Technical Service Bulletin: 10-1978

Forest River is alerting you to an issue involving certain 2026 Flagstaff FLT25FBD & Rockwood RLT2522FB Travel Trailers. Please see the information below, which describes the issue and provides you with details on the steps you should take to have your vehicle repaired.

2522FB/25FBD Black & Grey Tank Repair

Step 3

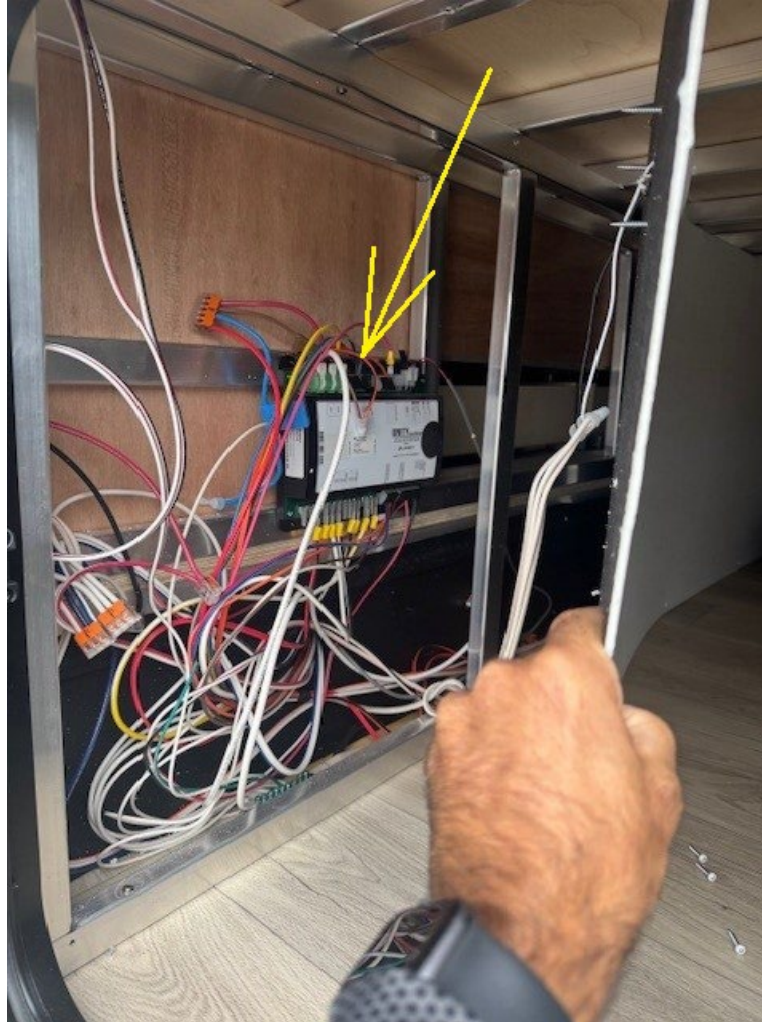
- Find where the tank wires are attached to the controller and confirm that the brown and grey wires are reversed as shown
